Docket No. 50-29

This refers to your Proposed Change No. 100, dated May 16, 1972, and supplemental information contained in your teletype of May 18, 1972, requesting authorization of a change in the Technical Specifications appended to License No. DPR-3 for the Yankee reactor. The proposed change would modify the control rod withdrawal program to allow operating the reactor with one of the 24 control rods inoperable.

YANKEE NUCLEAR
POWER STATION

FIGURE
103-5

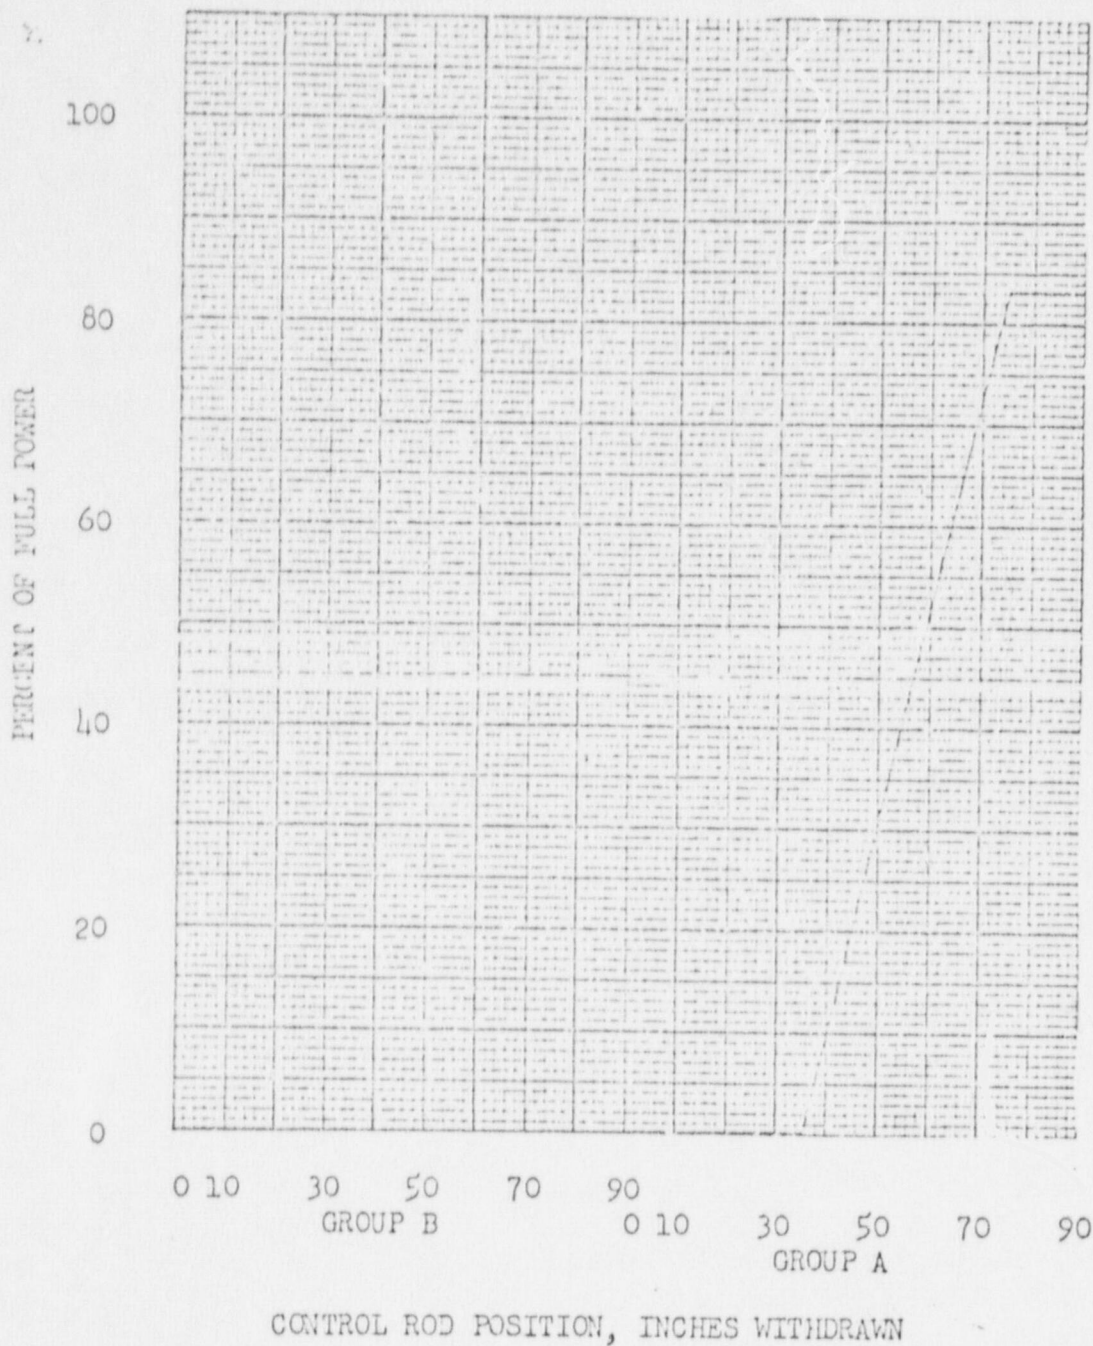
To meet the specified shutdown margin with control rod No. 18 inoperable, you propose the revised control rod withdrawal program shown on Figure 103-5 in Proposed Change No. 100. This program requires full withdrawal of Control Rod Group B (compared with the presently specified 50 inches withdrawal limit); it also requires 35 inches withdrawal of Control Group A for allowing the reactor to attain criticality. The additional control rod withdrawals are provided to offset the shutdown reactivity assumed to be unavailable from the inoperable control rod No. 18. You have also determined that the additional control rod withdrawal must be compensated by adding more boron to the reactor coolant to an increased boron concentration of about 2350 ppm at zero power.

We have reviewed the information you have submitted on your evaluation of the safety considerations associated with the change in the control rod withdrawal program, including the effects on accidents analyzed previously. Additional control rod withdrawal essentially improves

the hot channel factors as determined previously in the thermal and hydraulic analysis for Core X. We have therefore concluded that the change in the control rod insertion limits will not decrease the Core X margins of the hot channel factors or the DNB ratios. The added control rod withdrawal in conjunction with the needed increase in the boron concentration will result in operational restriction on reactor power at about 83% of licensed power and consequent decrease of the reactor coolant average temperature from 530°F to 514°F. This will result in an increase of important margins of safety. Further increase of boron in the reactor coolant and the increase in control rod withdrawal would affect only the boron dilution accident assumed to occur when the reactor is at full power. Your reanalysis of this accident shows that the increase in the reactivity addition during the accident that results in an increase of the DNB ratio for operation with 4 loops and a decrease of the DNB ratio from 1.92 to 1.88. We conclude that this decrease is not significant compared with the required DNB ratio of 1.3.

Accordingly, pursuant to Section 50.59 of 10 CFR Part 50, the control rod withdrawal program is changed as indicated in the attached Figure 103-5.
